MAINE TURNPIKE AUTHORITY

ADDENDUM NO. 2

CONTRACT 2022.07

INTERCHANGE IMPROVEMENTS

SHEET NUMBER: LP-10
255 OF 735

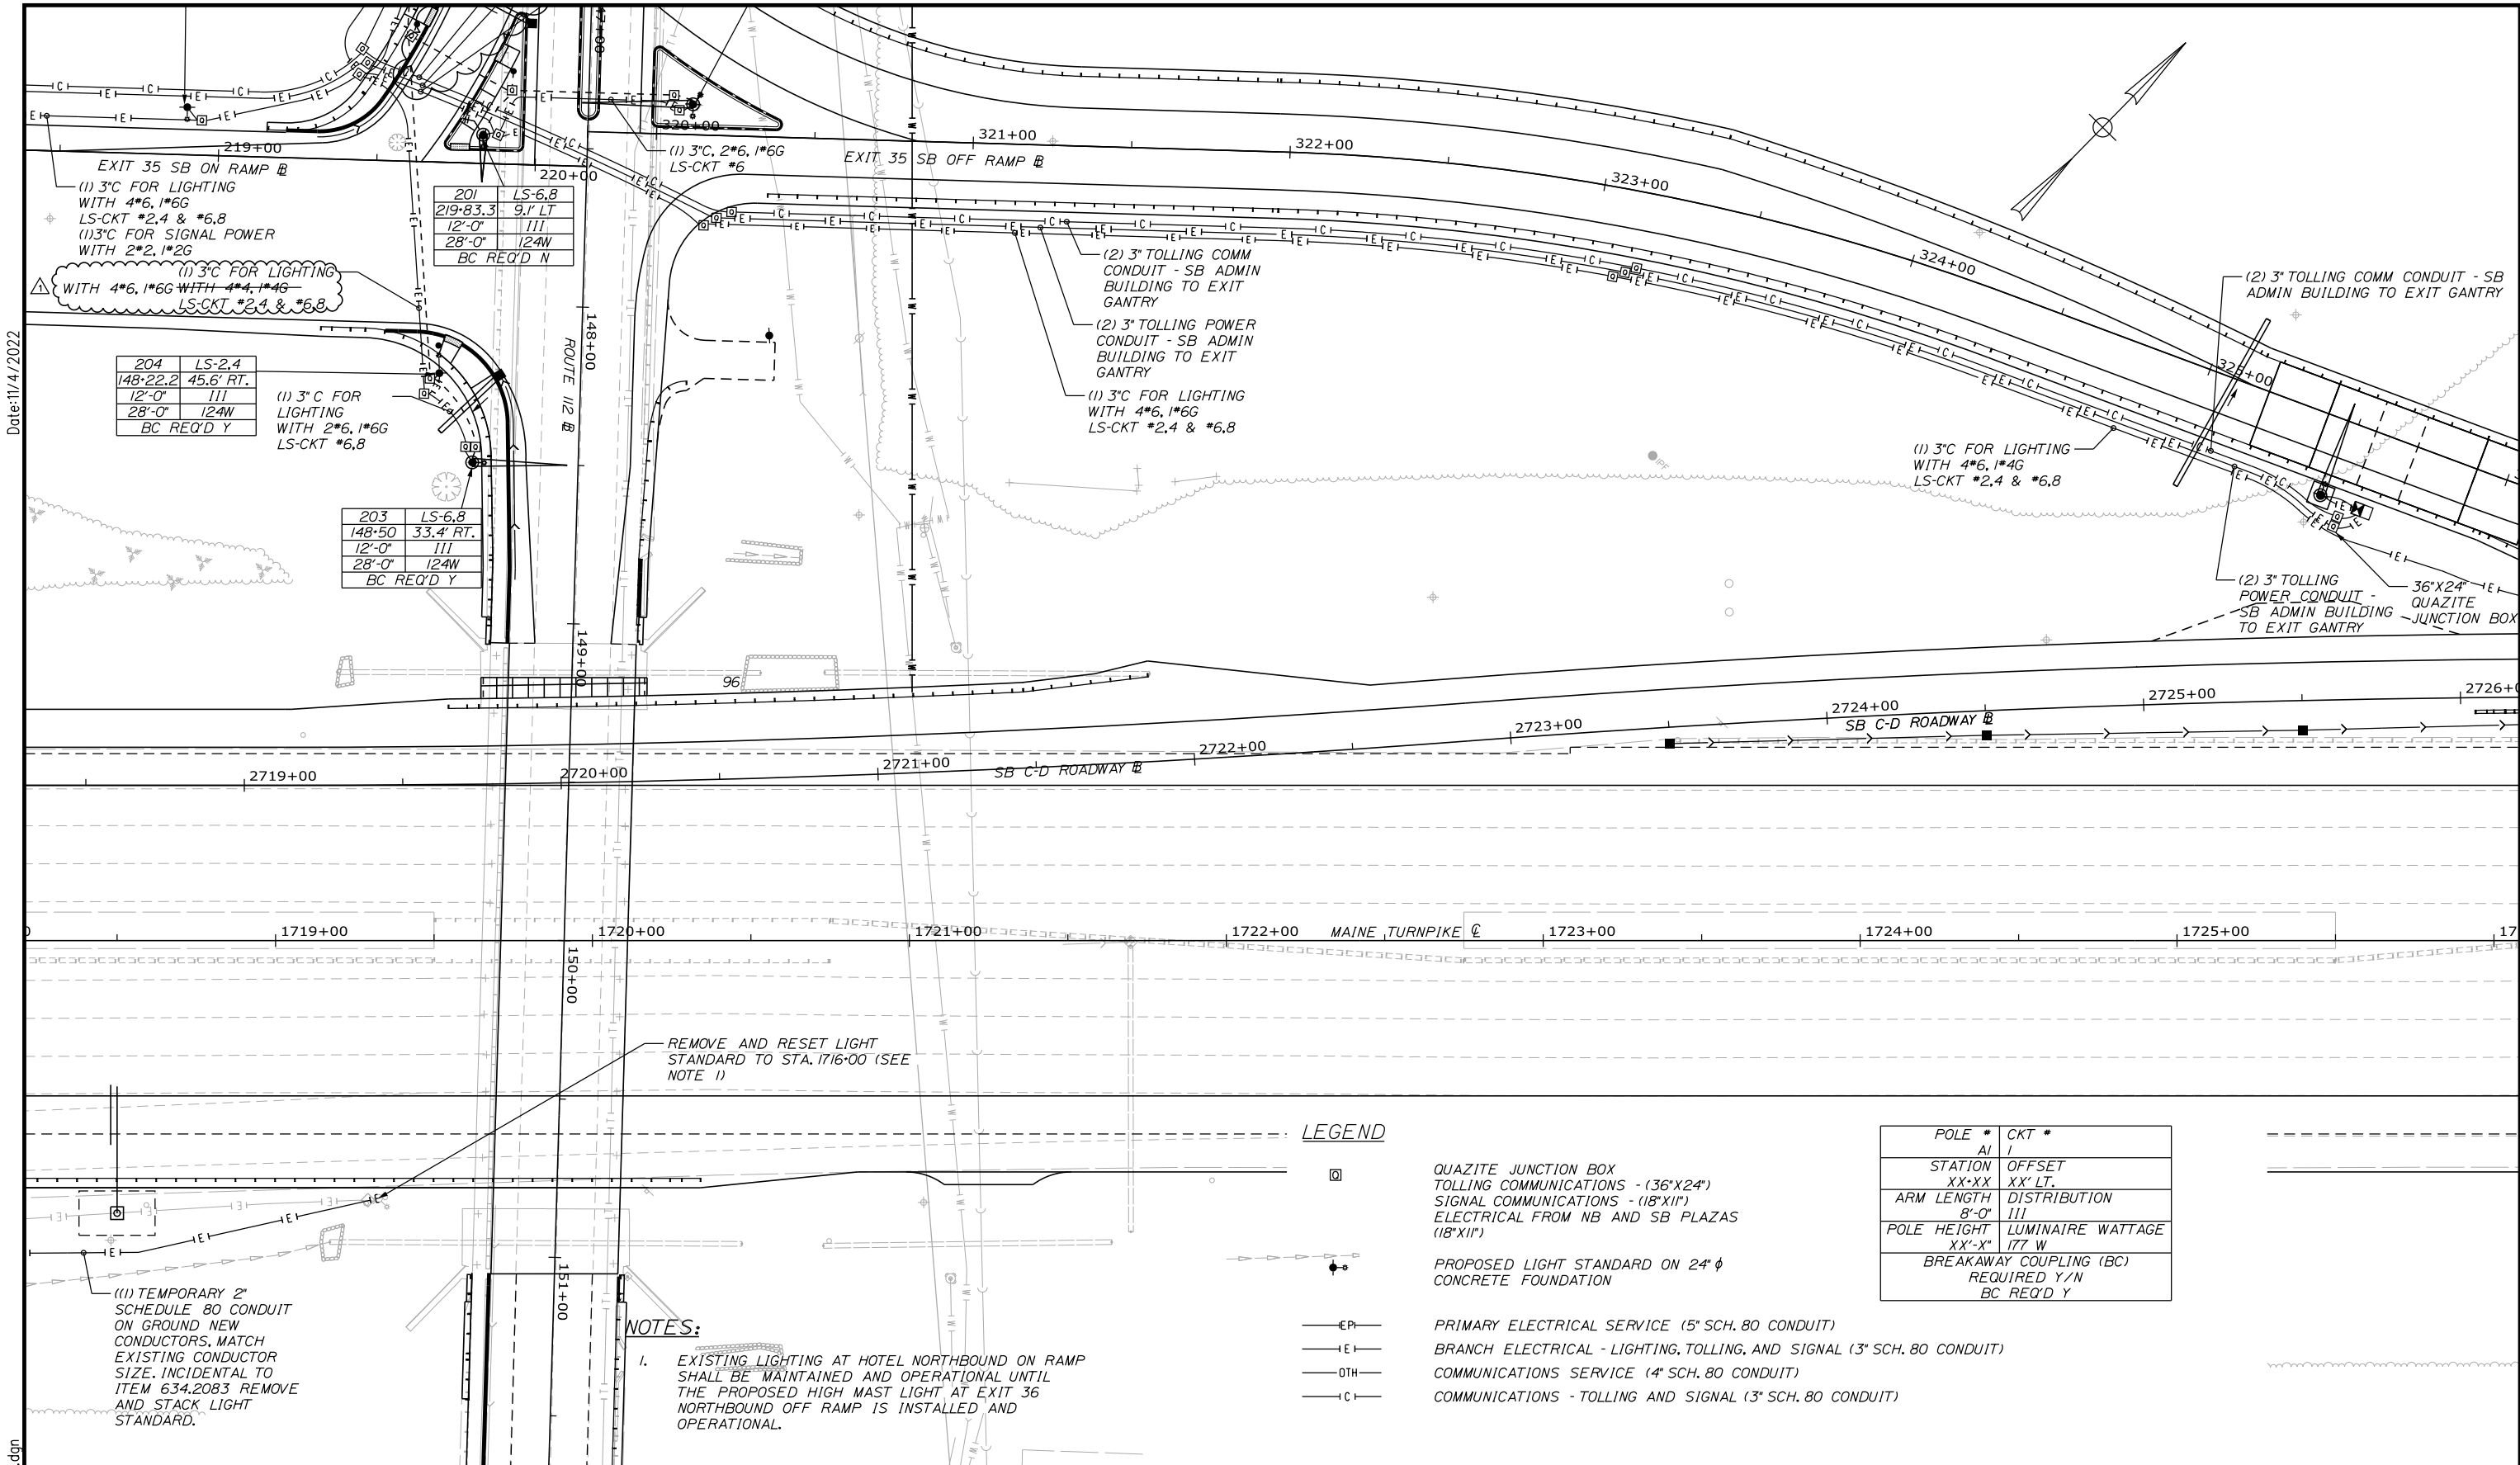
10. Question: Power & Comm Plan 9 (Sheet 255) Station 219+50. Is the #4 wire mislabeled crossing the ramp headed southeast? Its #6 wire on both sides of that circuit, but #4 crossing the Ramp.

12. Question: Power & Comm Plan 10 (Sheet 256) shows (2) 3” Tolling Comm, (2) 3” Tolling Power and (1) 3” site lighting. Those same quantity of conduits don’t seem to carry through the intersection on Plan 9 (Sheet 255) station 219 to 220+50. The notes for the 2 #1 & 1 #1G don’t seem to carry to the exit toll or back to a power source.

Answer: Yes, the wire size has been changed from #4 AWG to #6 AWG on Sheet 255 in Addendum No. 2.

Answer: Tolling Comm and Power quantities and sizes stay the same. See Toll System Drawings for Gantry Power conductor sizes. Notes have been added to Sheet 255 in Addendum No. 2. Traffic signal controller no longer crosses street and the (1) 3”C for Signal Power with 2#1,1#1G at street crossing has been eliminated on Sheet 256 in Addendum No. 2.

No.	Revision	By	Date
Δ	REVISED NOTE	JRH	11/22

SHEET NUMBER: LP-17
262 OF 735

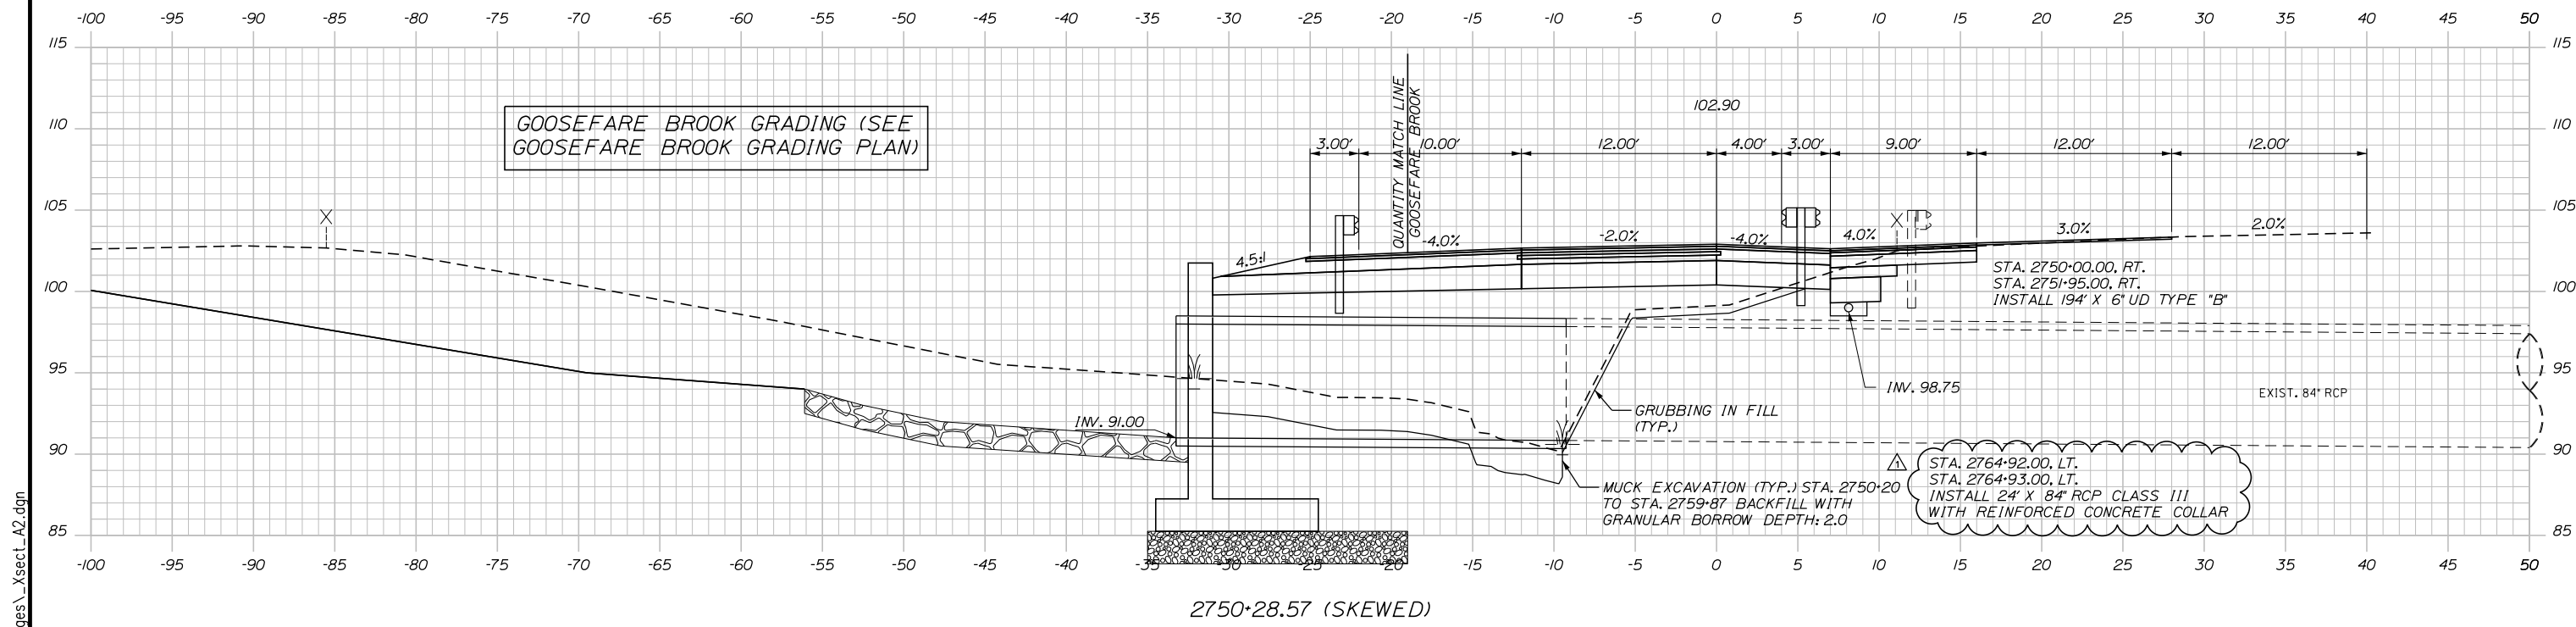
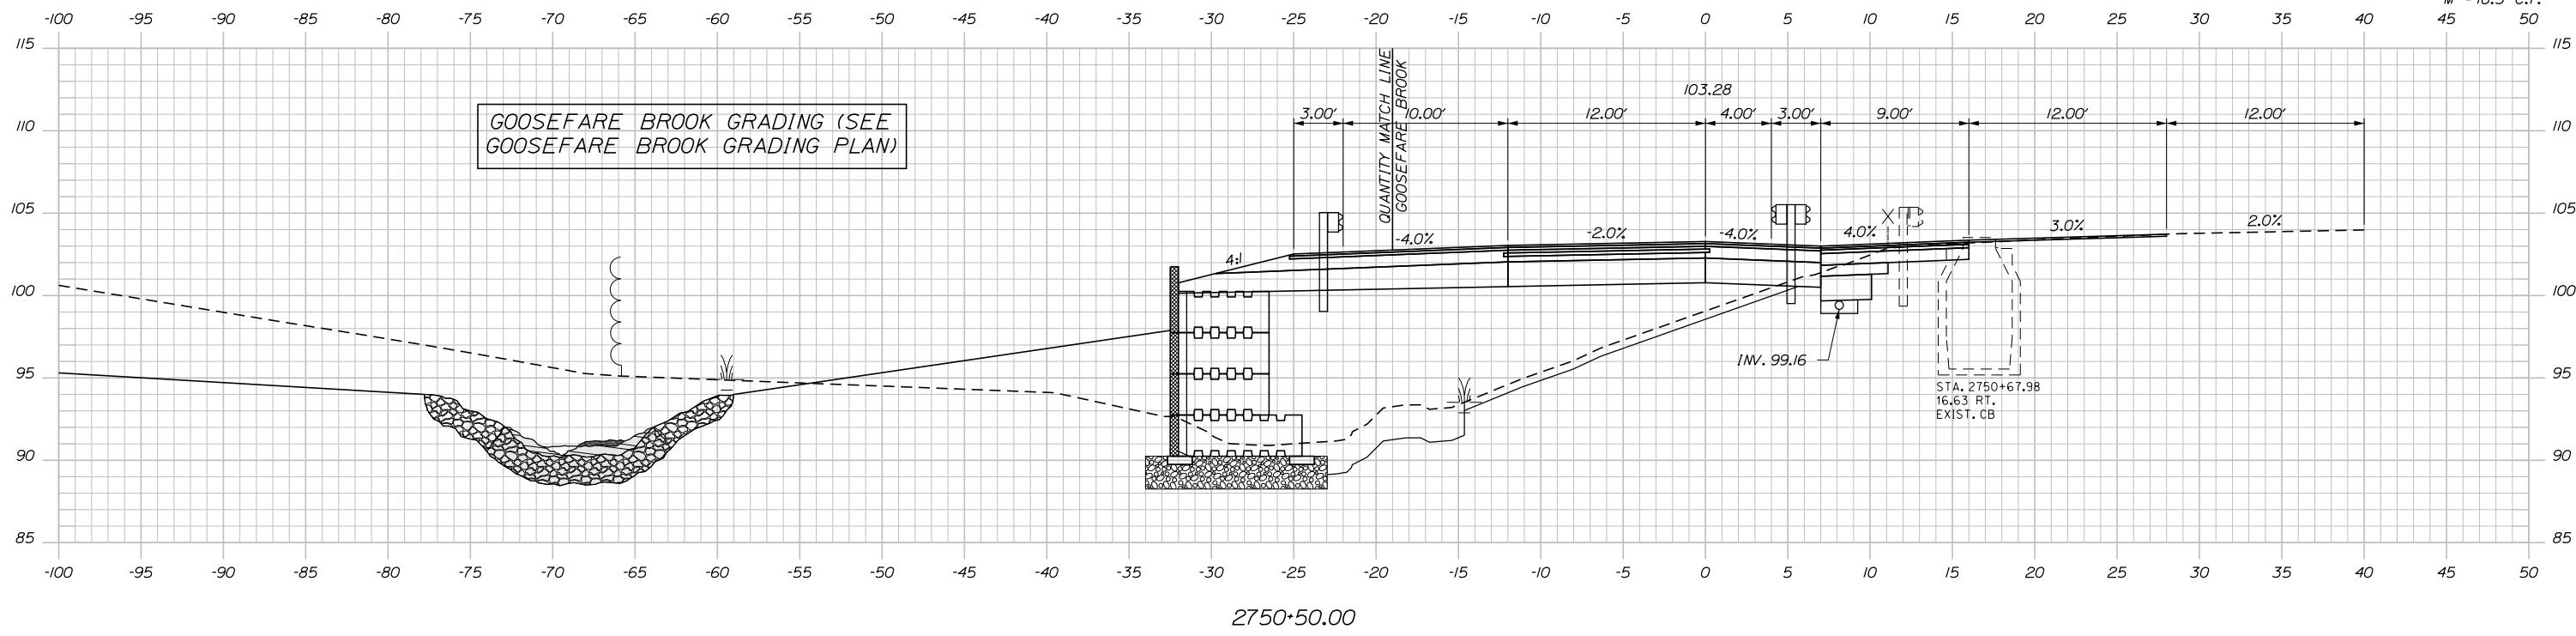
15. Power & Comm Plan 16 (Sheet 262) Directional Drill across highway has 6 #2 and 1 #2G. Conduit station 2753 +75 to 2755+25 and the second directional bore has 8 #2 and 1 #2G. From there it takes off with #6’s. Please confirm this is correct.

Answer: Yes, feed from panel is #2 AWG and then changes to #6 AWG at handholes shown on plan. The number of wires have been changed from 8 wires to 6 on Sheet 262 in Addendum No. 2.

No.	Revision	By	Date
1	REVISED NOTE	JRH	11/22

SHEET NUMBER: GB-09
CONTRACT: 2022.07
608 OF 735

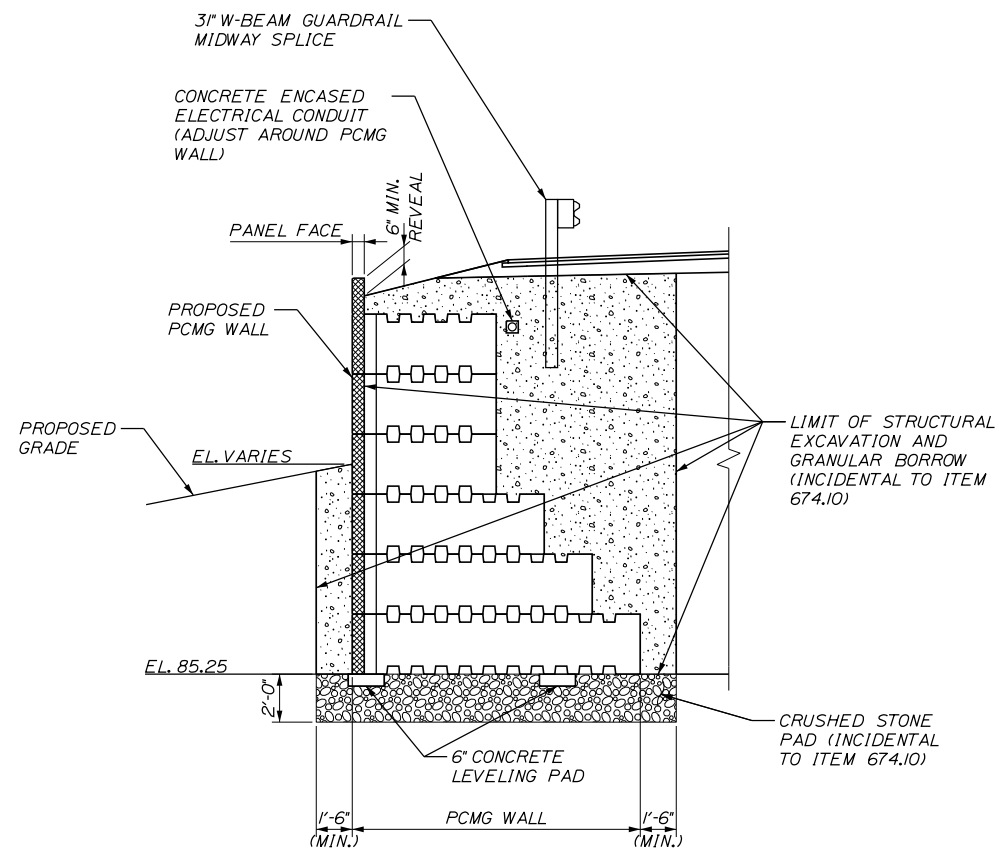
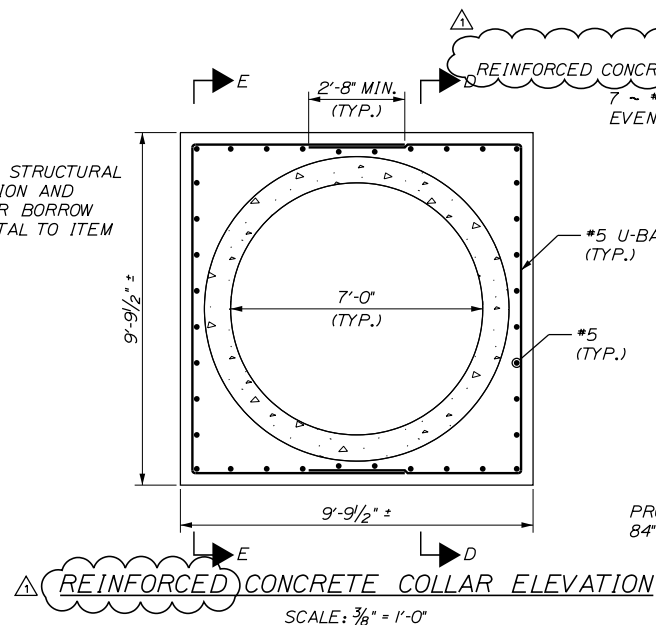
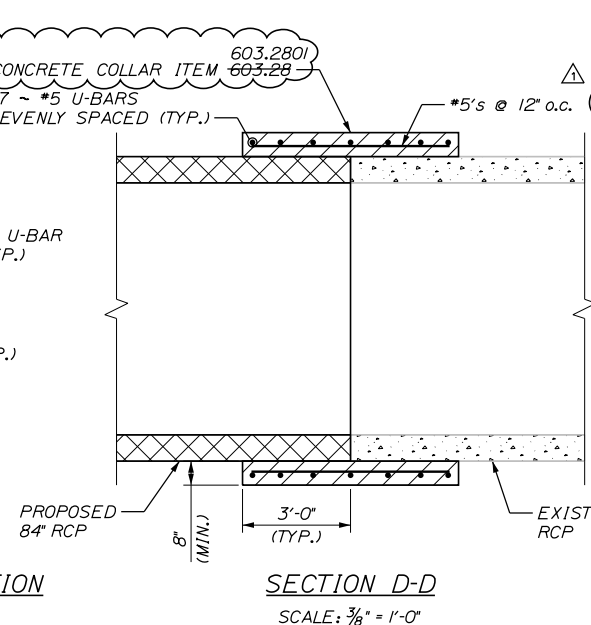
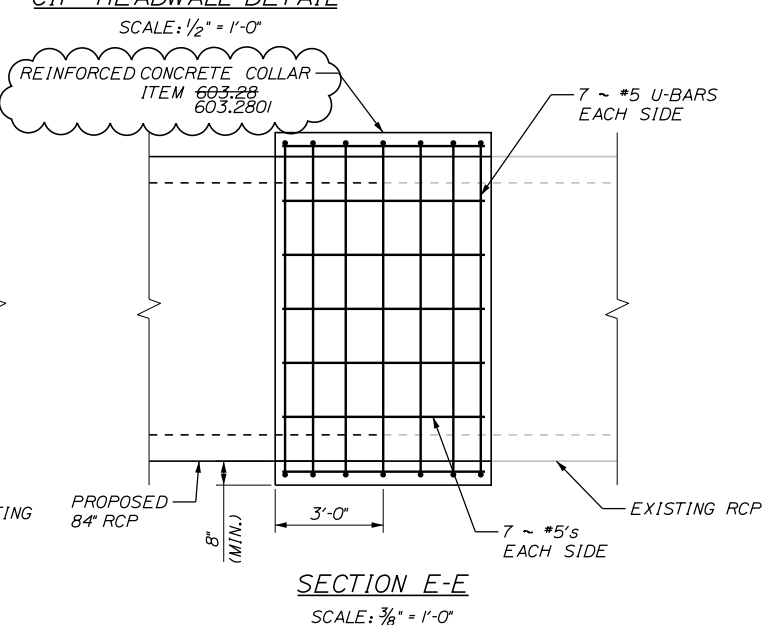
20. On sheet 608 of the contract plans, the Goosefare Brook concrete collar is called out as item 603.28. There are 11 other collars that have significantly less scope. Will the MTA consider making the Goose Fare Brook Collar its own item.

Answer: Yes. Item 603.2801 - Reinforced Concrete Collar has been added for the Goosefare Brook culvert in the plans and special provisions in Addendum No. 2.

Scale: AS NOTED			
No.	Revision	By	Date
1	ADDED REINFORCED CONCRETE COLLAR	JRH	11/22
